<b>Notice of Allowability</b>	<b>Application No.</b>	<b>Applicant(s)</b>	
	10/712,033	NICOT ET AL.	
	<b>Examiner</b>	<b>Art Unit</b>	
	Barry J. Gooden Jr.	3616

**EXAMINER'S AMENDMENT**

FIG. 2

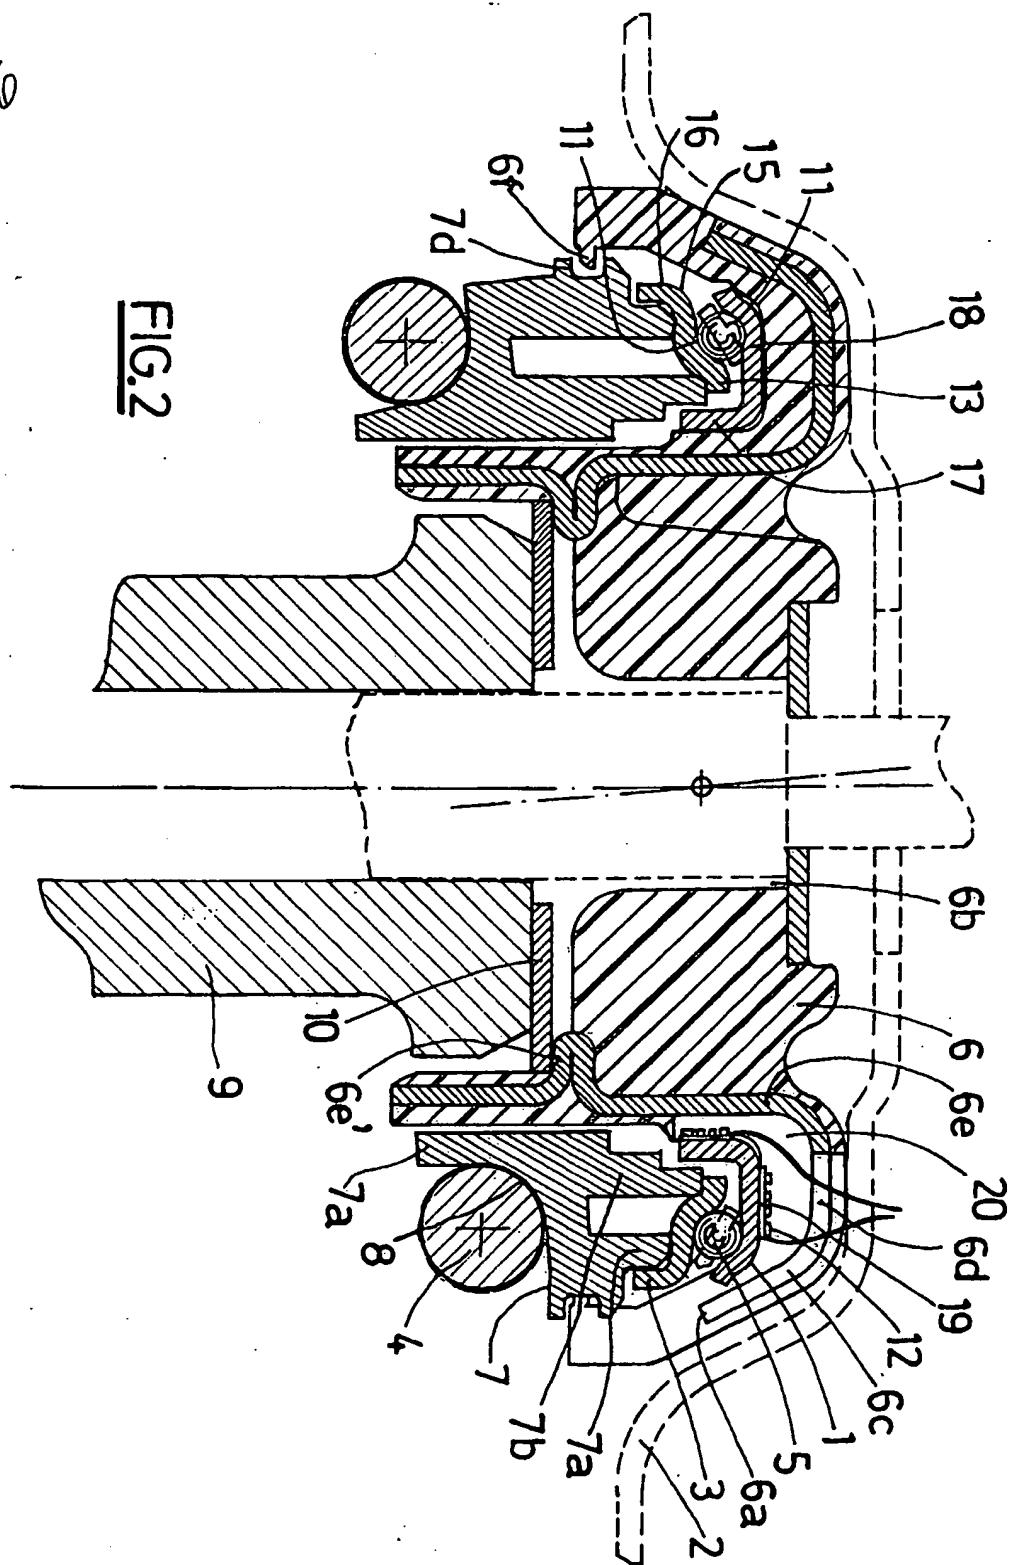
3. The following changes to the drawings have been approved by the examiner and agreed upon by applicant: the cross-hatching will be altered for clarity purposes. In order to avoid abandonment of the application, applicant must make these above agreed upon drawing changes.

Examiner has included a copy of suggested changes to the drawings and requests applicant submit new, formal drawings with careful attention to the proper labeling of the parts, such as the sensors, and the disclosed means of illustrating missing hatching.

From the original drawings and specification it is apparent the top cup (6) extends circumferentially about the top race (1) and is engaged with the top race; however, due to the method of illustration, the drawings appear to indicate otherwise. Clearly the hatching for the top cup was omitted for illustrative purposes, as the device would not function without the engagement between the top cup and the top race. The device as claimed including the "at least one deformation sensor which is associated with the top race so as to measure the deformations of the top race", defines over the prior art.

Approved  
QC  
9/11/11
